SUBJECT: Interagency Agreement No. NRC-03-79-167 Task No. 1 - Midland Plant  
Units 1 and 2, Subtask 3.

2. A listing of the questions <sup>generated as</sup> a result of the review of Midland Unit 1 and 2 follows:

SUBJECT: Interagency Agreement No. NRC-03-79-167 Task No. 1 - Midland Plant  
Units 1 and 2, Subtask 3

<b>BECHTEL</b> ANN ARBOR	
<b>MIDLAND POWER PLANT</b>	
MEASURED VS PREDICTED SECONDARY COMPRESSION SETTLEMENT (8-15-79 / 6-12-80) ASSUMING SURCHARGE REMAINS	
<b>JOB NO.</b>	<b>DRAWING NO.</b>
<b>7220</b>	<b>FIGURE 27-15</b>

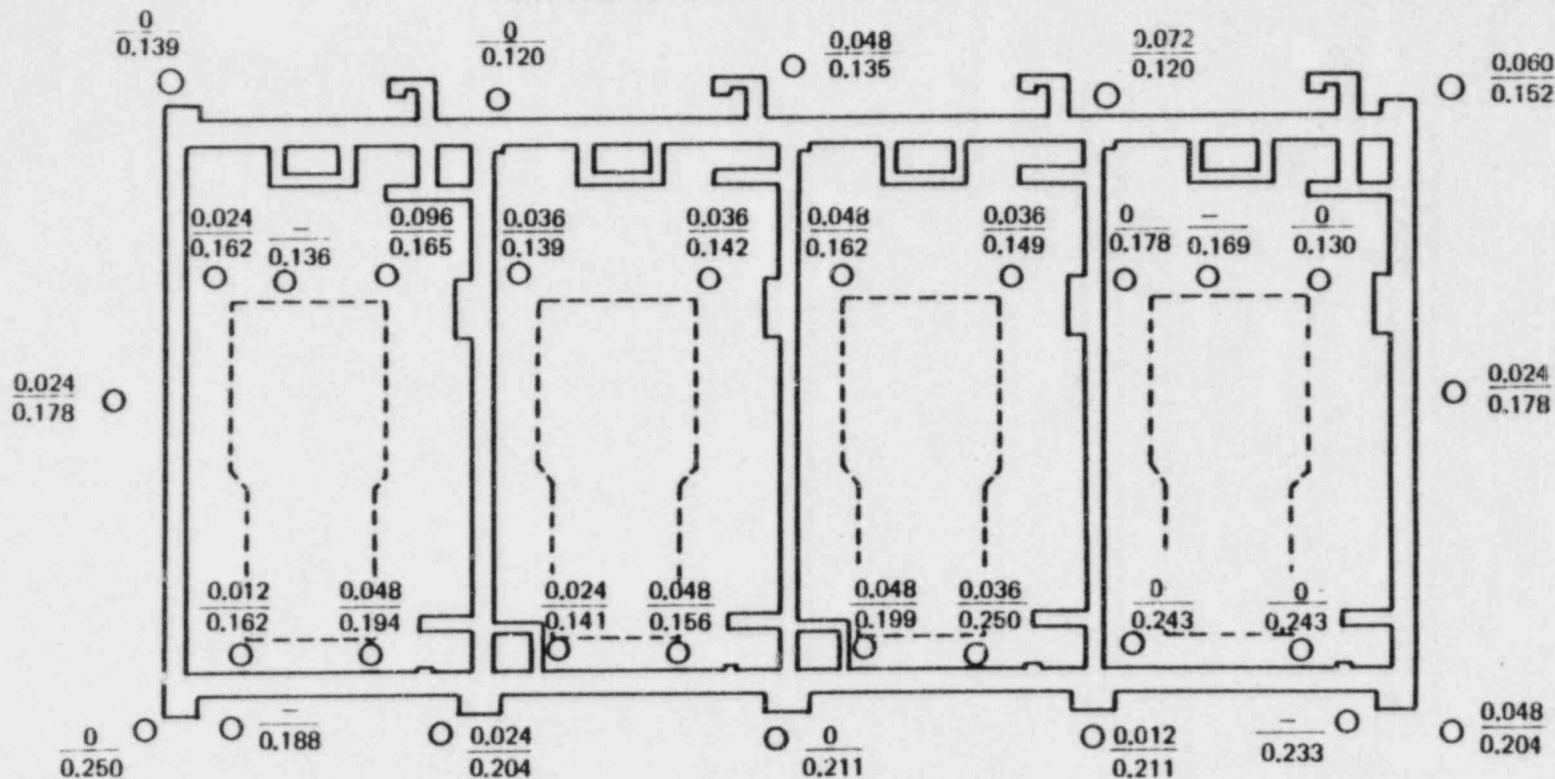
In response to NRC question 27 (10 CFR 50.54f), the applicant has attempted to justify the results of the preload tests as realistic and valid information to predict the future settlements of the Diesel Generator Building and the machine pedestals. In Subsection C, Method of Prediction, on page 27-3, it has been stated that primary consolidation was accomplished quickly after completion of the placement of fill. This was shown by observing that pore pressures were smaller than actually anticipated, and they dissipated rapidly as shown in Figures 27-7a and b.

A review of the piezometer readings obtained after the removal of the surcharge load (PZ-1, PZ-13, PZ-21, PZ-40, PZ-37, etc.) shows a trend of sharp decrease in piezometric heads indicating that excessive pore water pressure was not completely dissipated, and as such, the primary consolidation was incomplete. The gradual slow rise in piezometric head with time, after a sudden drop in the head upon removal of the surcharge could be due to the water table under the preload area not having reached a state of equilibrium with the water level in the cooling pond. The water table was still rising at a decreasing rate under decreasing differential hydraulic head causing seepage through the fill material between the cooling pond and the preload area. The differential hydraulic head affecting the groundwater level under the preload area was less than, and was balanced by, the excessive pore pressure created by the preload and as such, stopped seepage from the pond to the preload area during the surcharge period. As soon as the excessive pore pressure disappeared due to removal of the surcharge, the water table started rising which has been indicated by the rise in piezometric head after the removal of the surcharge.

(I) The excessive pore water pressure created by the surcharge was not dissipated before the removal of the surcharge load.

(II) The primary consolidation was not 100% complete.

(III) The consolidation parameters obtained from the preload test results cannot be used to accurately predict the future settlements of the Diesel Generator Building.
